Canyon Fuel
Company, LLC.
Sufco Mine

Re: Tipple Building Modification Amendment, 2nd Submittal, Canyon Fuel Company, LLC,
SUFSCO Mine C/041/002

This resubmittal has been revised to clarify and address the deficiencies in the Division letter dated September 15, 2008 received on September 26, 2008.

Figure 5-0D - Tipple Building Modification

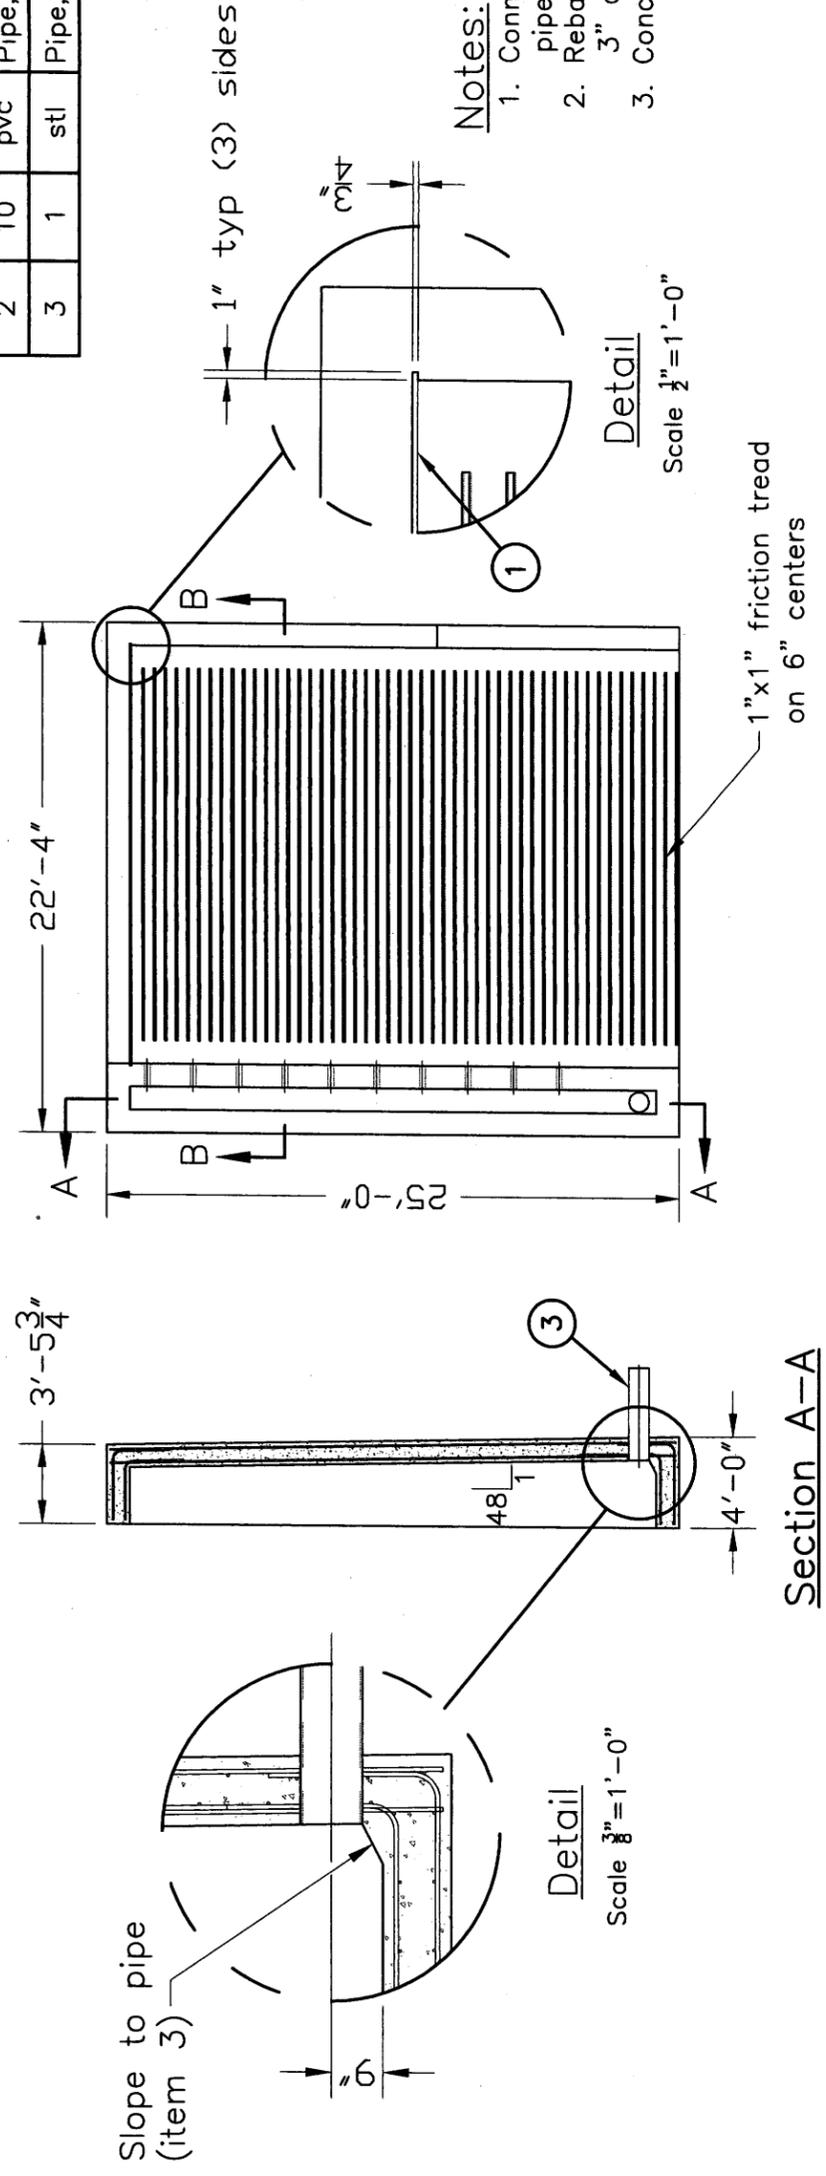
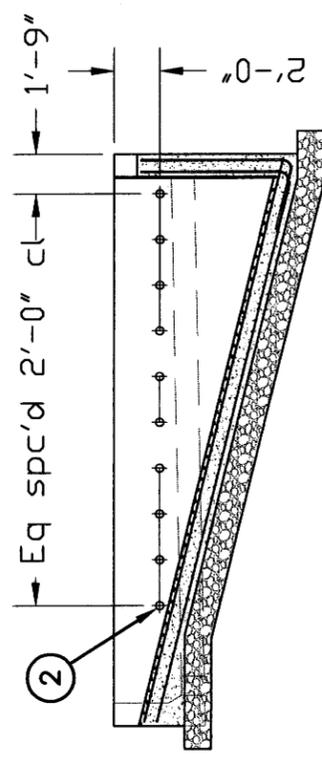
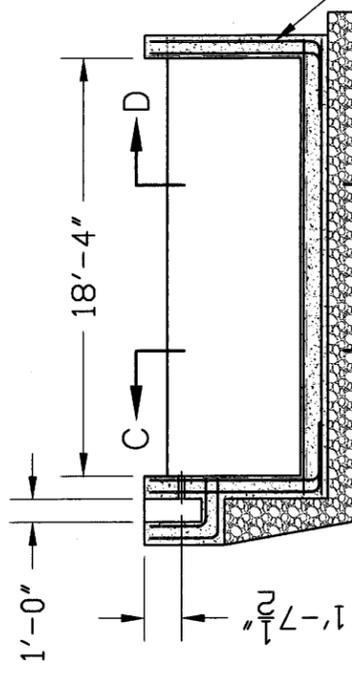
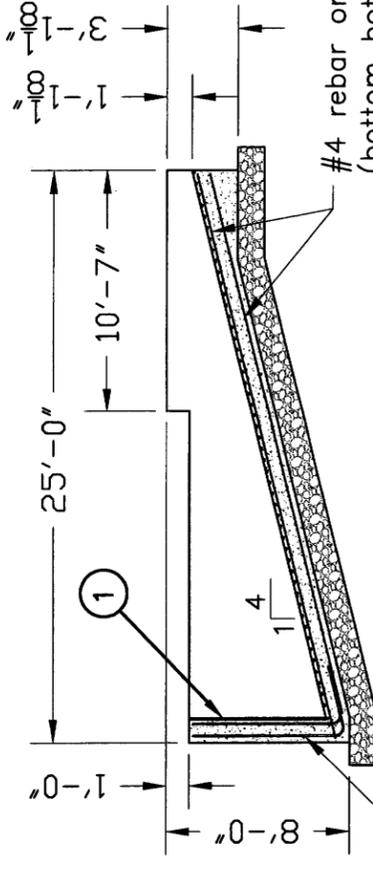
1. **There is no written description of the structure in the MRP.**

5. The purpose of the structure is not stated.

Modification description, design and cross section figures were added to the text of the MRP in Chapter 5, Section 5.2.1.1, Pages 5-9 to 5-11.

The purpose of the existing Tipple Building Sump is to collect the coal fines when the Tipple Building is being cleaned. This allows a loader to collect the coal fines from the sump and put them on the coal storage pile. The existing Tipple Building Sump is being modified to widen the sump to accommodate the use of a larger loader for cleanout. The Tipple Building Sump is part of the Tipple Building structure. Tipple Building Modification description, design and cross section figures were added to the text of the MRP in Chapter 5, Section 5.2.1.1, Pages 5-9 to 5-11.

Chapter 5, Section 5.2.1.1, Page 5-9 – Tipple Building Modification description, design and cross section figures were added to the text of MRP.

Tipple Building was modified in 2008 to widen the tipple building sump to accommodate the use of a larger loader to collect coal fines when the Tipple Building is being cleaned. This allows a loader to collect the coal fines from the Tipple Building cleanup and put them on the coal storage pile preventing them from being washed through the mine yard. Design and cross sections of the Tipple Building Modification are provided on Figures 5-0C and 5-0D.
